# HISTORIC AND DESIGN REVIEW COMMISSION

December 02, 2020

**HDRC CASE NO:** 2020-449  
**ADDRESS:** 522 N HACKBERRY ST  
**LEGAL DESCRIPTION:** NCB 570 BLK 6 LOT S 50 FT OF 1 & 2  
**ZONING:** RM-4, H  
**CITY COUNCIL DIST.:** 2  
**DISTRICT:** Dignowity Hill Historic District  
**APPLICANT:** ANNA SALCEDO LIEBERS  
**OWNER:** BLACK BRICK URBAN HOMES LLC  
**TYPE OF WORK:** Construction of a 2-story residential structure  
**APPLICATION RECEIVED:** October 30, 2020  
**60-DAY REVIEW:** Not applicable due to City Council Emergency Orders  
**CASE MANAGER:** Edward Hall

The applicant is requesting a Certificate of Appropriateness for approval to construct a 2-story, multi-family residential structure on the vacant lot at 522 N Hackberry, located within the Dignowity Hill Historic District.

1 SITE PLAN  
SCALE: 1/8=1'-0"

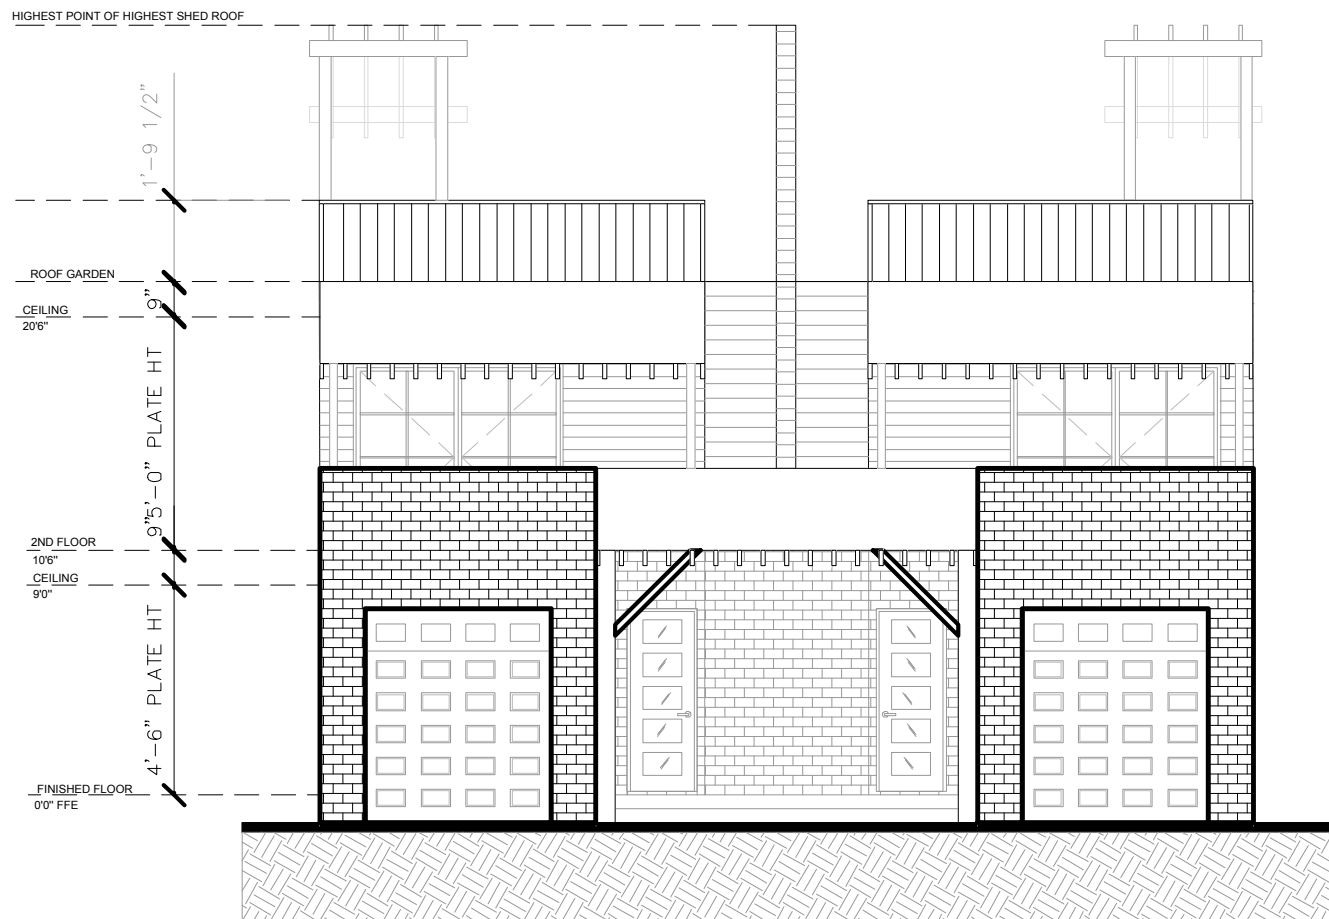
- c. **SETBACKS & ORIENTATION** – According to the Guidelines for New Construction, the front facades of new buildings are to align with front facades of adjacent buildings where a consistent setback has been established along the street frontage. Additionally, the orientation of new construction should be consistent with the historic examples found on the block. The applicant has not provided information regarding setbacks on the submitted site plan. Staff finds that new construction should feature a setback that is equal to or greater than those found historically on the block. Given the proposed height of two stories, staff finds that a greater setback would be most appropriate.

- o. **PARKING (Garages)** – The applicant has proposed two, front loading garages. Front loading garages are not found historically within the district and are not consistent with the Guidelines. The proposed front loading garages should be eliminated from the design. Additionally, any parking configuration that promotes a front yard parking condition should be avoided.

- p. **DRIVEWAYS** – The applicant has proposed two (2) driveways to provide access into the site. Lots within the Dignowity Hill Historic District historically feature one (1) driveway per lot. Staff finds that only one driveway should be installed.

- q. **FRONT WALKWAY** – Structures located within the Dignowity Hill Historic District traditionally have walkways that lead from the front porch to the right of way. The applicant has not incorporated these into the design. Staff finds that one walkway should lead from primary entrance to the sidewalk at the right of way.

- i. That the applicant provide documentation noting that the proposed new construction will feature a setback that is equal to or greater than those found historically on the block, as noted in finding c.

- ix. That unique porch massing is incorporated into the design as noted in findings d and n.
- x. That the proposed double driveway and front loaded garage configuration be eliminated, as noted in findings n, o and p.

- xi. That a landscaping plan be developed to include a front walkways and that all mechanical equipment be screened from view at the public right of way as noted in findings q, r and s.

## FRONT BUILDING ELEVATION

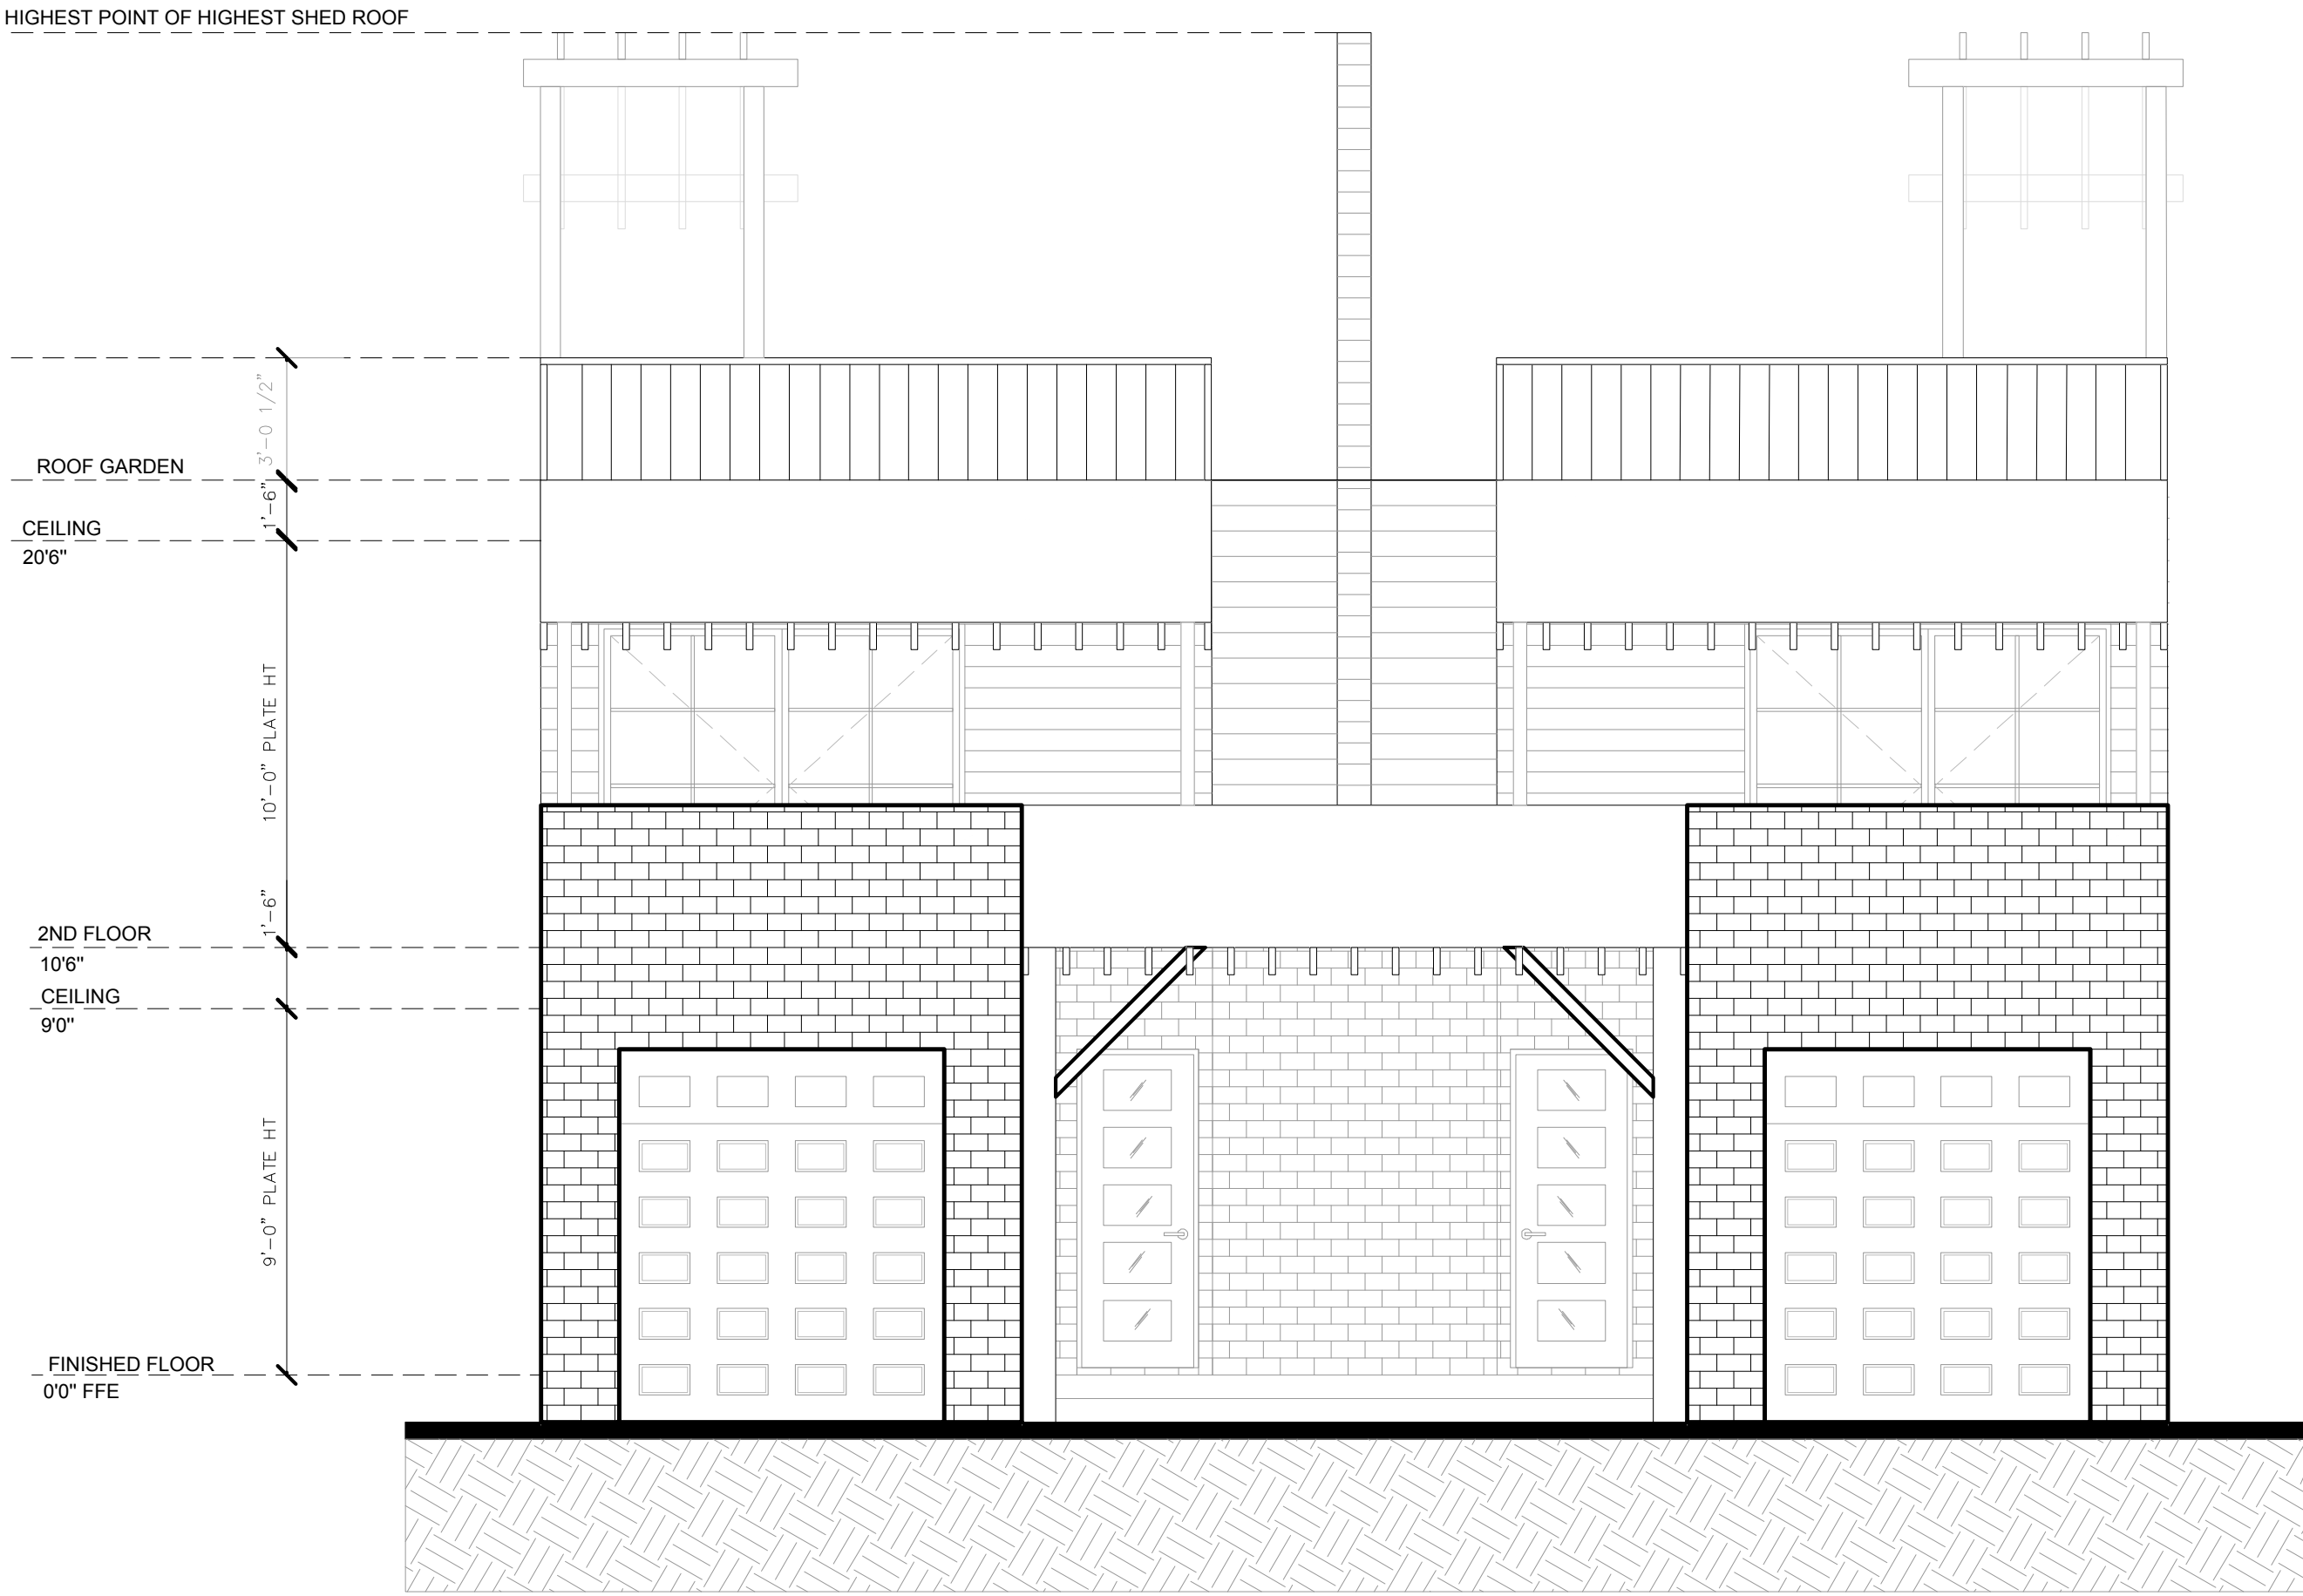
- d. **ENTRANCES** – According to the Guidelines for New Construction 1.B.i., primary building entrances should be oriented towards the primary street. The applicant has proposed entrances that face N Hackberry; however, staff finds that one entrance should be eliminated. Additionally, staff finds that the redesigned entrance should be designed to feature architectural elements that traditionally accompany the entrances found on historic structures within the district, such as porch elements.

- e. **SCALE & MASS** – Per the Guidelines for New Construction 2.A.i., a height and massing similar to historic structures in the vicinity of the proposed new construction should be used. In residential districts, the height and scale of new construction should not exceed that of the majority of historic buildings by more than one-story. While a proposed height of two stories is within the Guidelines, staff finds that the proposed massing is atypical for the district and inconsistent with the Guidelines. Traditional forms, including façade arrangement, roof forms, and porch forms should be incorporated into the design.

- f. **SCALE & MASS (Width)** – The applicant has proposed a total width of approximately forty (40) feet. This is wider than the structures found historically on this block. Staff finds that the proposed width of new construction should be comparable to the widths of structures found historically on this block.

- g. **FOUNDATION & FLOOR HEIGHTS** – According to the Guidelines for New Construction 2.A.iii., foundation and floor heights should be aligned within one (1) foot of neighboring structure's foundation and floor heights. Per the submitted elevations, the proposed foundation heights are not consistent with the Guidelines.

- h. **ROOF FORM** – The applicant has proposed for the structure to feature a flat roof with various flat roof planes. This block of N Hackberry features historic structures with gabled and hipped roofs. The proposed roof form is not consistent with the Guidelines.

- j. **MATERIALS** – The applicant has proposed materials that include brick and composite siding. Brick is atypical for residential construction within the district. The proposed materials, with the exception of horizontally oriented lap siding are not consistent with the Guidelines, as they are not found predominantly within the Dignowity Hill Historic District.

- l. **WINDOW & DOOR OPENINGS** – Per the submitted documents, the applicant has proposed window profiles that are atypical of those found historically within the district. The proposed windows feature sizes that are larger than those found historically within the district, or feature non-traditional profiles, such as fixed, square windows. Staff finds that windows that are consistent with those found historically within the district in regards to size and profile be installed.

- ii. That the applicant eliminate one of the proposed entrances, and develop entrance elements for one entrance that are consistent with the Guidelines and those found historically within the district, as noted in finding d.

- iii. That the applicant propose an overall width that is comparable with those found historically on the block, as noted in finding e.
- iv. That the applicant incorporate foundation and floor heights that are consistent with the Guidelines as noted in finding g.

- v. That the applicant incorporate roof forms that are consistent with the Guidelines as noted in finding h.
- vi. That the propose stucco and faux wood siding are eliminated from the proposed design, as noted in finding j.

- vii. That window materials adhere to staff's standards for windows in new construction as noted in finding k.
- viii. That fenestration patterns, profiles and openings be modified to be consistent with the Guidelines and the historic examples found within the district, as noted in findings l and m.

## LEFT ELEVATION

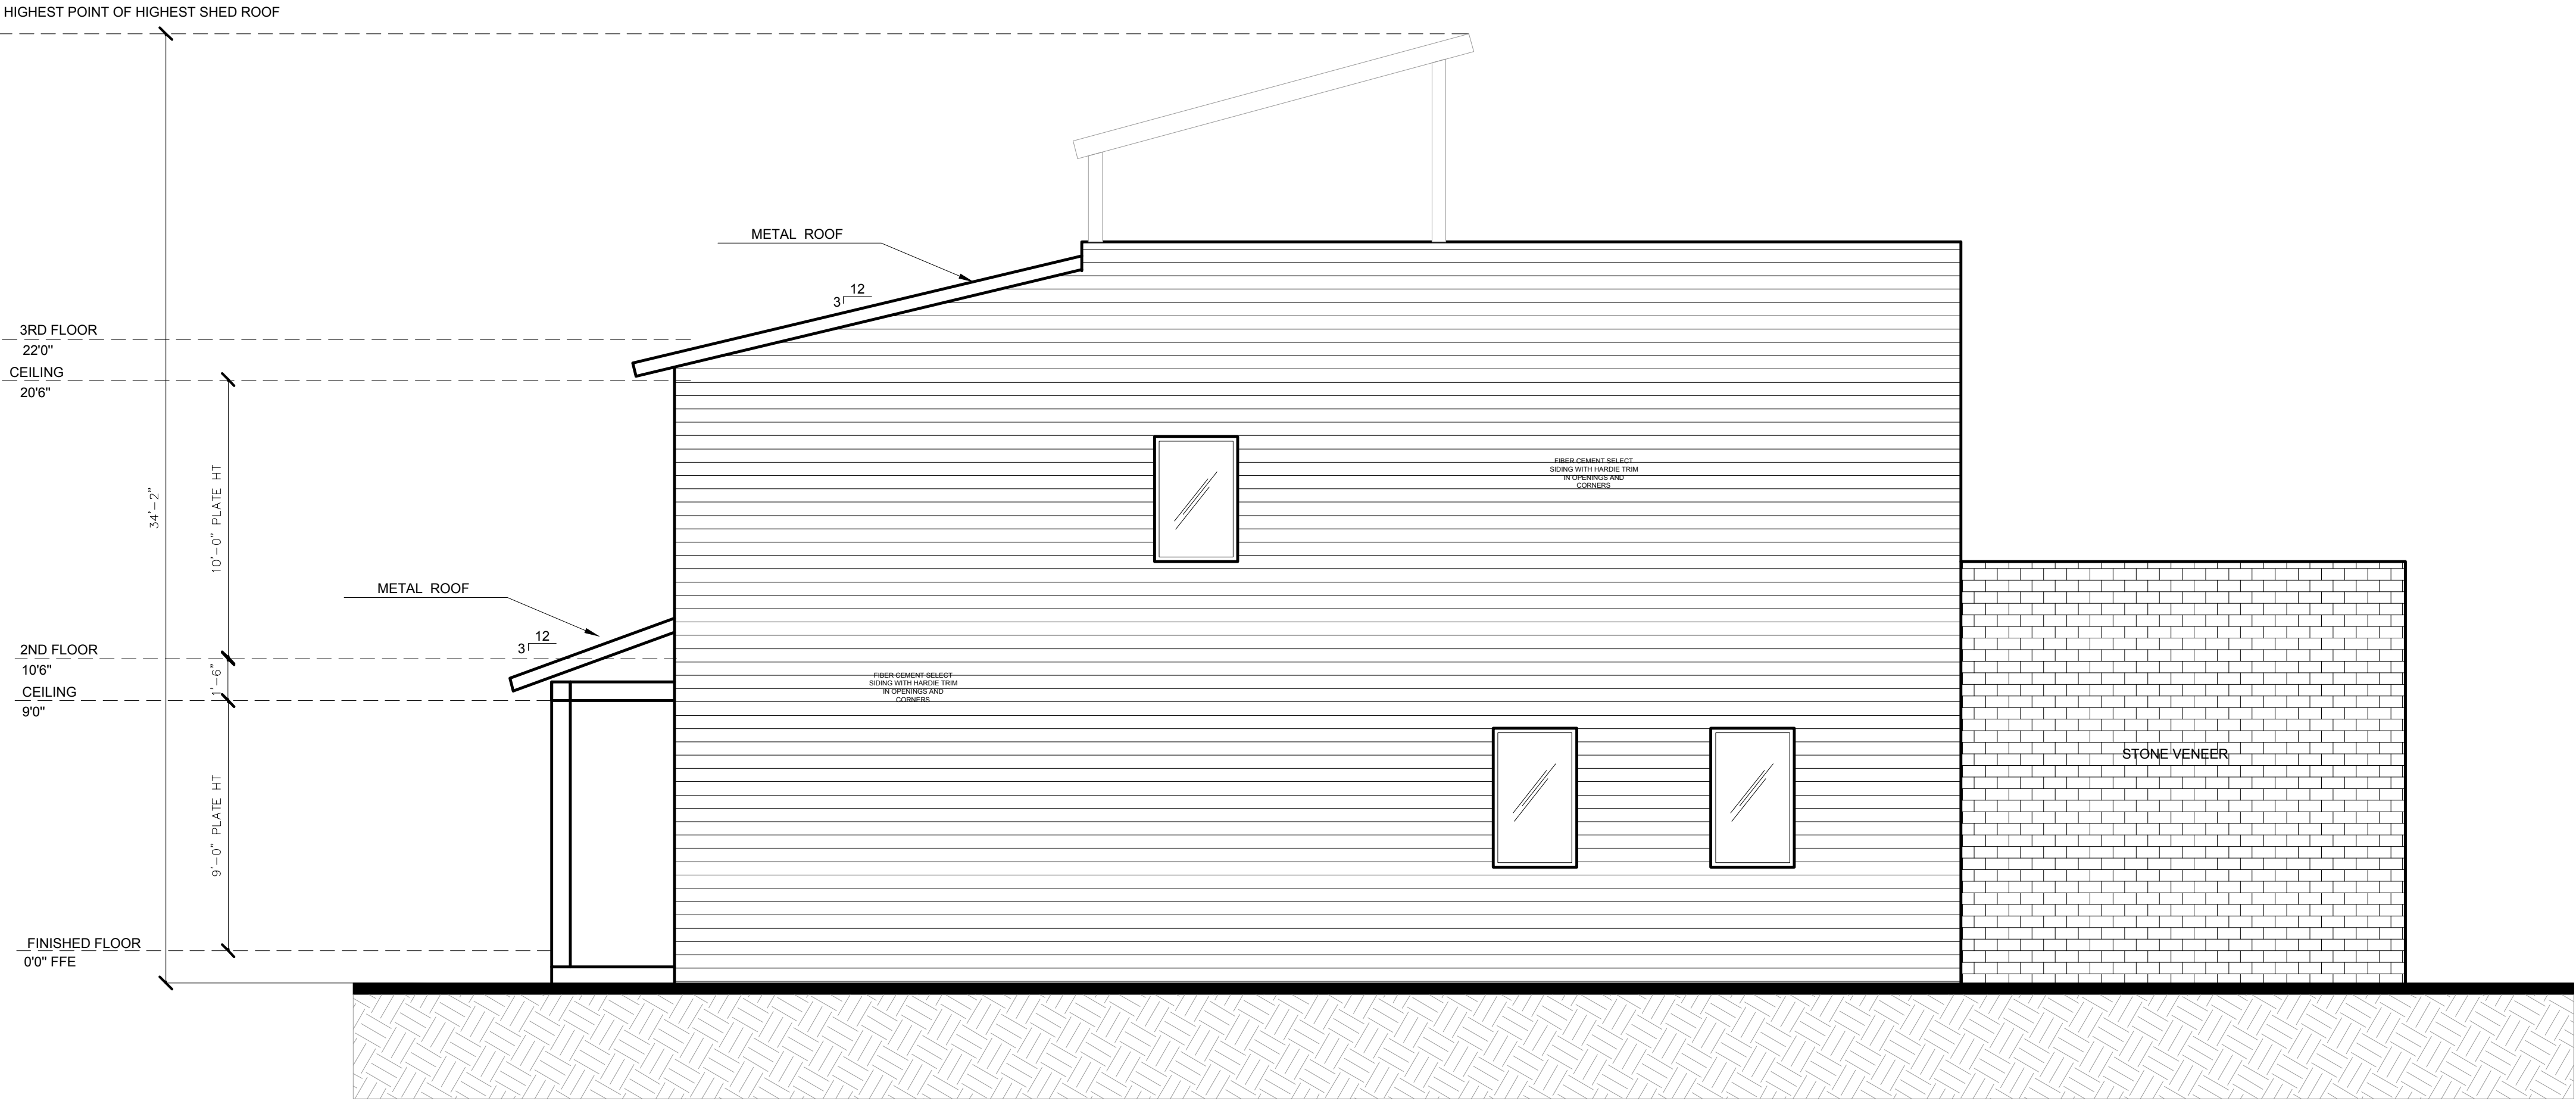
- m. **WINDOW & DOOR OPENINGS** – Per the submitted documents, the applicant has proposed blank walls near the front elevation on both side elevations. Staff finds that windows should be added to separate expanses of wall that do not feature windows. Additionally, window should be grouped in a manner that is consistent with those found historically on the block, be separated by a six inch wood mullion rather than siding, feature a one over one profile and equally sized sashes.
